FINAL
ANNUAL REPORT AND YEAR THREE REVIEW
FOR THE ASH LANDFILL OPERABLE UNIT
SENECA ARMY DEPOT ACTIVITY

Contract No. W912DY-08-D-0003
Task Order No. 0001
EPA Site ID# NY0213820830
NY Site ID# 8-50-006

RESPONSE TO COMMENTS

Army's Response to Comments from the United States Environmental Protection Agency

Figure 7
Groundwater Elevations
Ash Landfill Annual Report, Year 3
Seneca Army Depot Activity

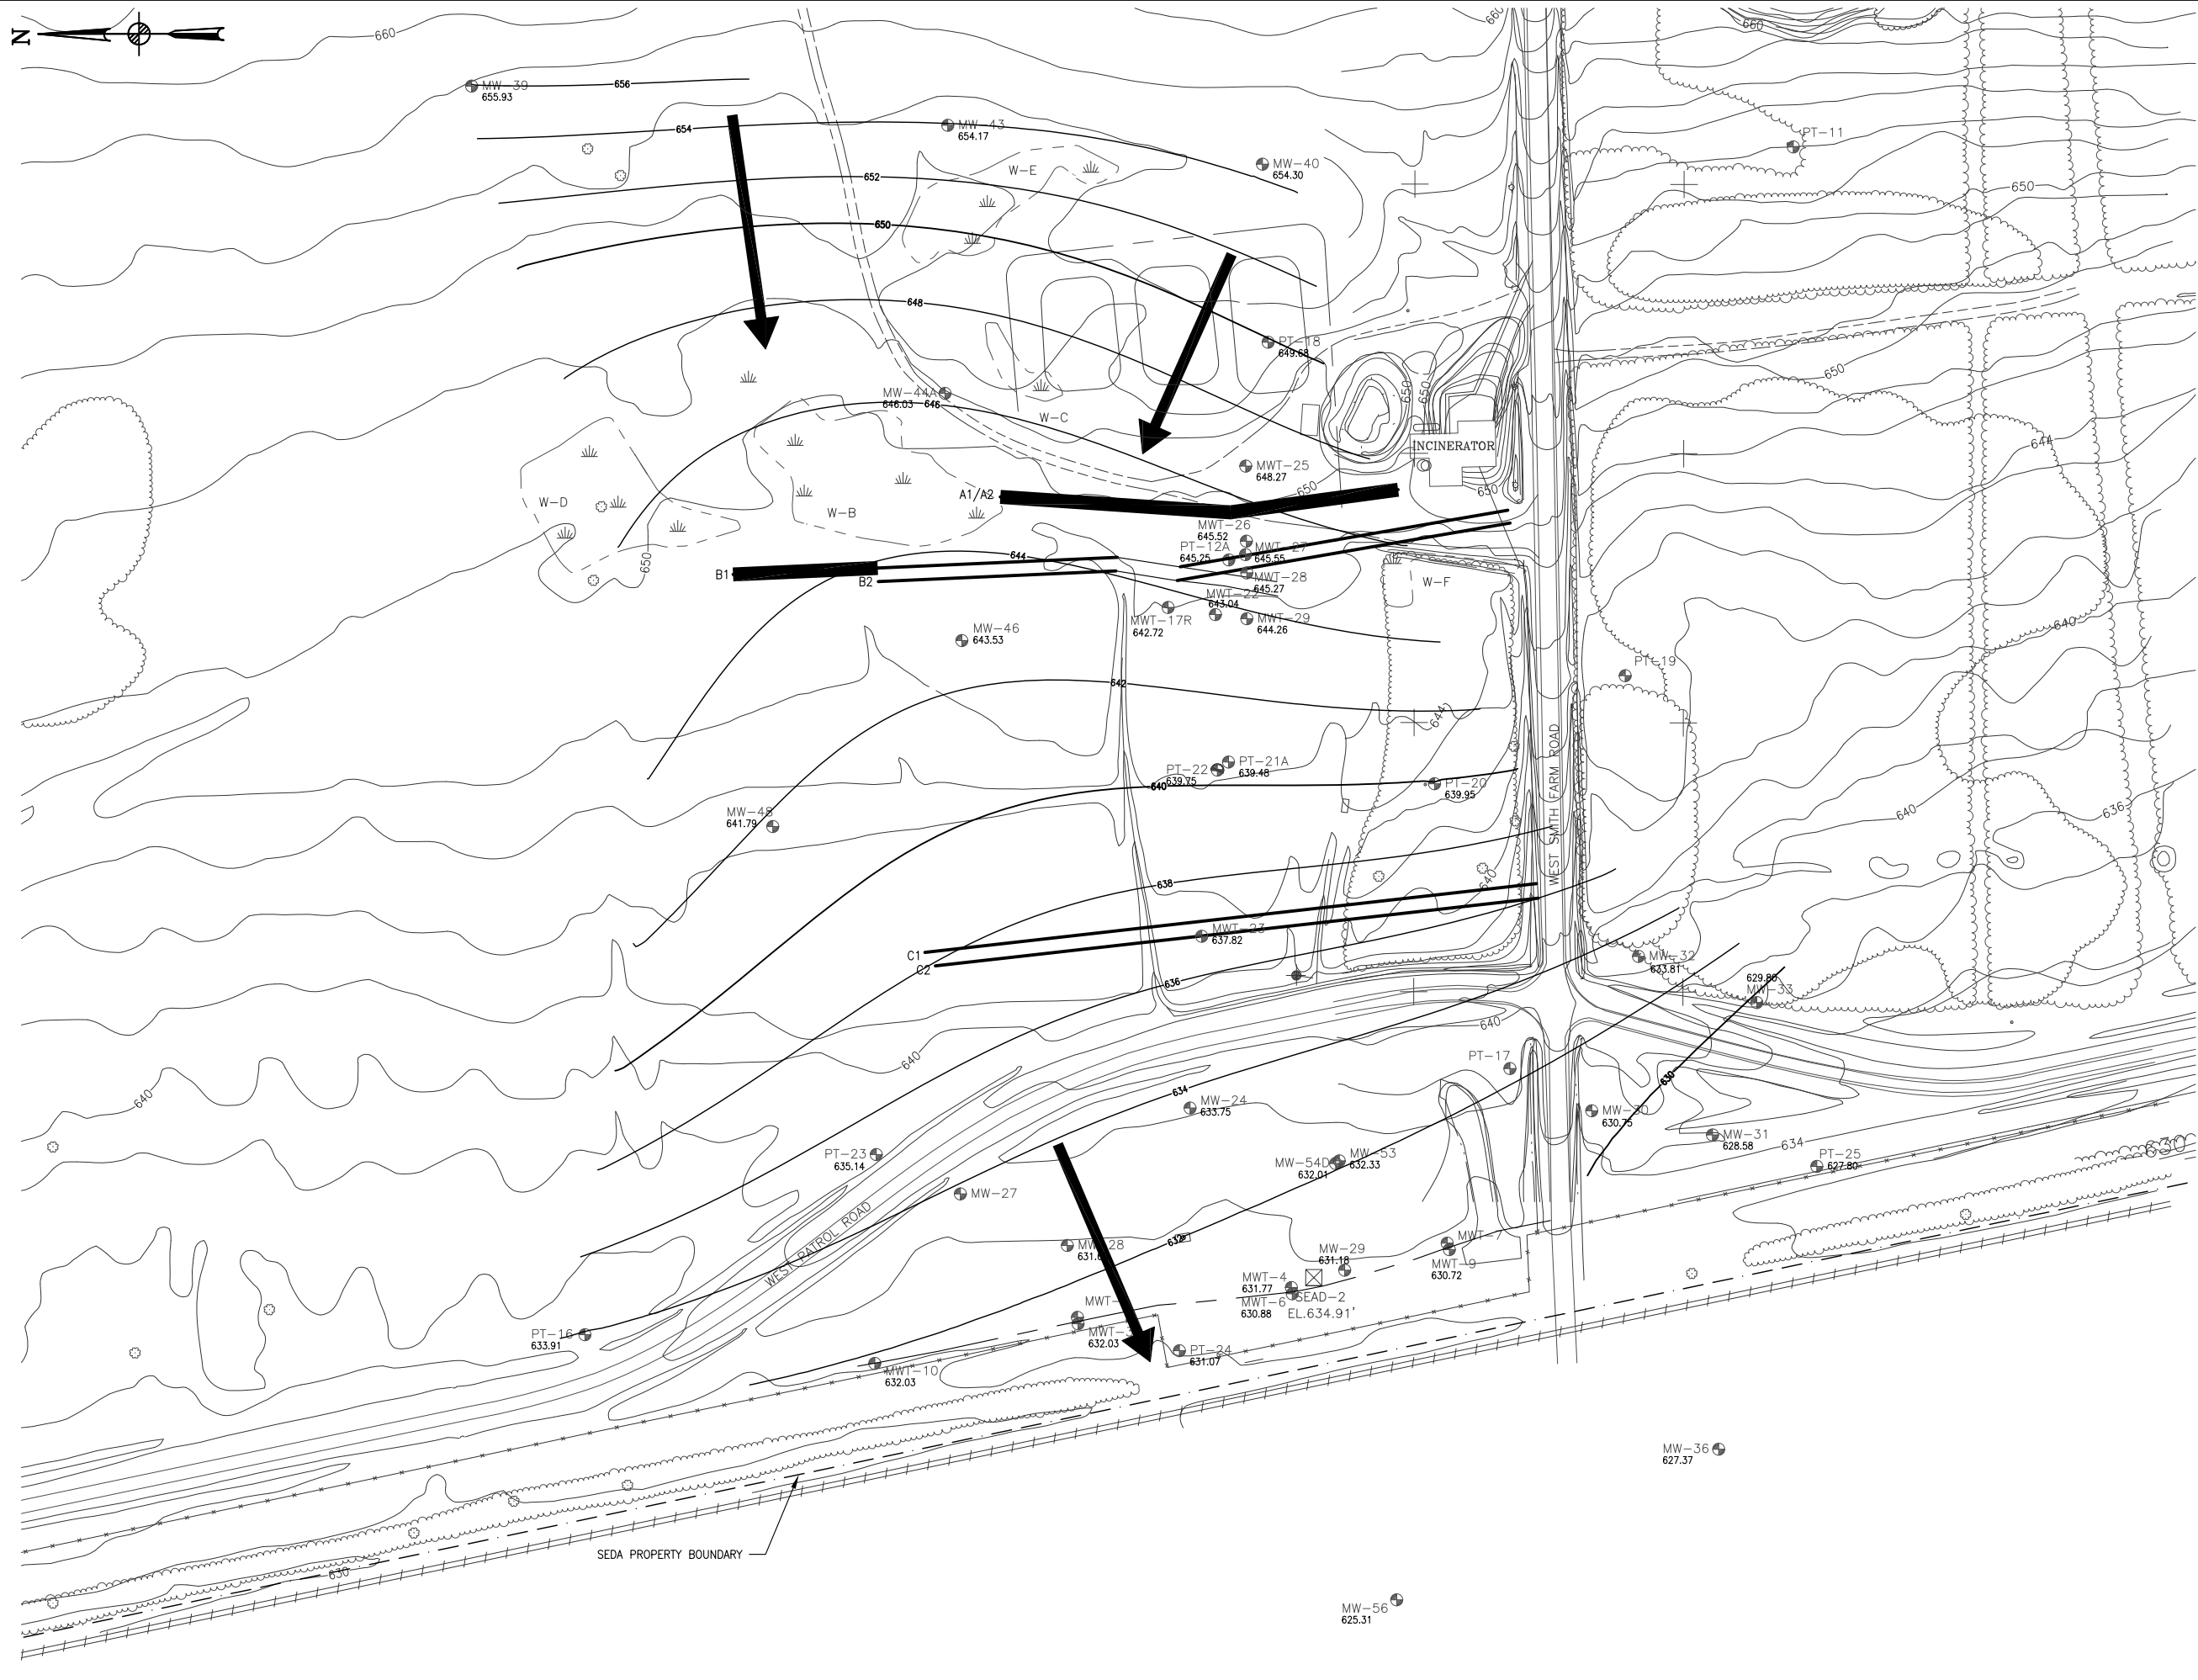
Comment 4: The Annual Report does not include a figure that plots groundwater elevations at the site by well location. Figure 4, Chlorinated Ethene Concentrations in Groundwater, includes a groundwater flow direction arrow, but the figure does not include any groundwater contours to support this groundwater flow direction. Revise the Annual Report to include a groundwater elevation map that is based on measurements collected during 2009.

Comment 6: Section 3.2, Groundwater Elevations, Page 10. This section references Figure 5, Groundwater Elevations, for historical groundwater elevation measurements. A note at the bottom of Figure 5 identifies three wells (MW-56, PT-17, and PT-18A) at which groundwater level measurements were not collected during various monitoring events. The Annual Report does not elaborate on why groundwater level measurements were not collected from these wells. For clarity, revise the Annual Report to explain why data are not available from these wells on various dates. In addition, it would be helpful if groundwater elevation data were also presented in a table as supporting documentation. Lastly, given the potential concerns associated with the plume leading edge vinyl chloride concentrations, a solid understanding of groundwater flow at the plumes leading edge is crucial. The Army will ensure any future sampling includes water level measurements from MW-56 and PT-17 to assist in refining groundwater flow directions at the plume leading edge.

Response 4: A figure showing the groundwater elevations at the Ash Landfill has been added as Figure 7, and a figure showing groundwater elevations during 8R2009 has been added as Figure 8. Subsequent figure numbers have been updated to reflect the addition of this figure.

Response 6: The omission of MWT-56, PT-17, and PT-18A is a data gap in the field collection due to human error. In the future, the Army will be certain that all relevant the wells are gauged. The groundwater levels and fluctuations at the Ash Landfill are well characterized, since the wells have been measured since the RI in 1994. A table presenting the historic groundwater elevations has been added to the Annual Report as Table 2. Subsequent table numbers have been updated to reflect the addition of this table.
